An Bord Pleanála, 64 Marlborough Street, Dublin 1, D01V902

Online submission 28.10.2022

Re: "DART+ West Electrified Railway Order 2022"

Figure 1 Section B-B stable lands on left, Section C-C stable lands on right.

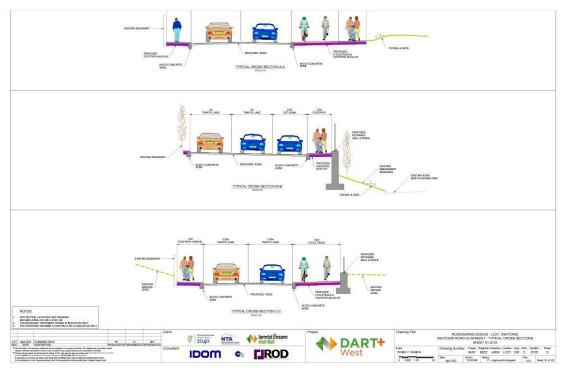
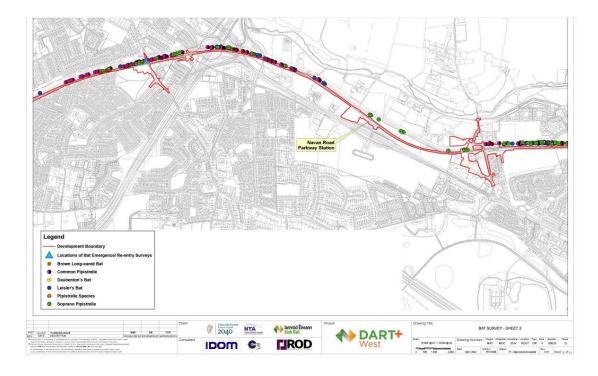
I welcome that item 4.1.1.1 Request for Avoidance of Relocation / Destruction of Ashtown Stables has been substantively addressed in the retention of Ashtown Stables in the current Railway order. However item 4.1.1.8 is of note here due to the high value biodiversity value of the site. In the submitted railway order the proposed works at Ashtown require a new access road and underpass to the west of the stables. This requires a partial CPO and temporary works CPO along the boundary condition of Ashtown Stables. The proposed development requires substantive tree and hedgerow removal from the southern portion of the lands of Ashtown Stables. No reference in the EIAR could be found in respect of mitigation vis a vis protected species on the lands of Ashtown Stables. No arboricultural survey appears in the publicly available documents online pertaining to the vegetation cover at the lands at Ashtown Stables. No detailed proposed planting plan has been presented in the publicly accessible documentation for Ashtown Stables. Section B-B for Ashtown on drawing 0105 appears to indicate the existing boundary is retained to the north eastern part of the lands. Section C-C requires a new boundary condition.

These drawings are schematic and lack detail. As no detail planting plan is proposed it is of concern as to the type of proposed species and specification of the any reinstatement planting. Some species such as oak for example are toxic to equines and are specified on the proposed planting schedules drawing, 15141.

The extent of land under CPO of the stable lands is not dimensioned where heavy intervention is proposed along the boundary condition. There is a lack of clarity on mitigation *if any* on the biodiverse integrity and green infrastructure of Ashtown Stables in the proposed Railway order for Dart West.

Figure 4 Top: Railway order Landscape impact drawing, Below: Railway order proposed mitigation. Note no trees noted for removal on southern part of Ashtown Stable lands under CPO in landscape impact drawing. These are noted for removal on the landscape mitigation drawing.

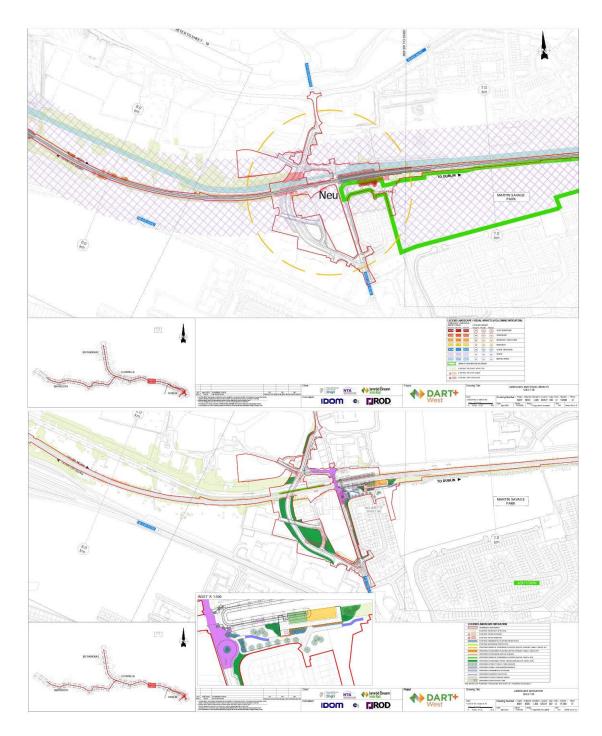
Here trees and hedgerows for removal are not documented in the landscape impact drawing yet is on the proposed mitigation plan. A new boundary condition is required to the south and south west. Yet the specific trees and hedging are not specified. For example Quercus robur (English Oak ) and Quercus palustris (pin oak) are described as the type of trees that may be used as street trees on drawing 15108. Both oaks are toxic to equines and demonstrates that no consideration was given to the planting scheme 15108 which pertains to Ashtown Stables. Quercus palustris is a non-native tree is inappropriate as a reinstatement of the native trees and hedgerow that are extant on the lands of Ashtown Stables. To the south west the existing vegetation, trees and hedgerow are noted as retained yet a new boundary condition is proposed on section C-C aforementioned. Any trees specified are at a maximum girth size of 10-12cm girth or maximum height of 2.5m tall or as whips at 900mm tall. 'Street' trees are a maximum size of 16/20cm girth (no height specified). 10-12cm girth is not a 'semi-mature' tree and whips at 900mm tall will be significantly poorer in visual amenity for the foreseeable future to that which the public currently enjoy. The meagre planting schedule presented cannot replace the current setting in any meaningful way.

There does not appear to be a consultant arborist involved in the production of information where no mitigation is proposed for tree or hedgerow retention. There are proposed changes in levels and excavation works proposed for road resurfacing along Ashtown Road and the proposed road. Therefore it would appear that it is likely that much of the existing bounded condition to Ashtown Stables will fail with the invasive nature of the works proposed.
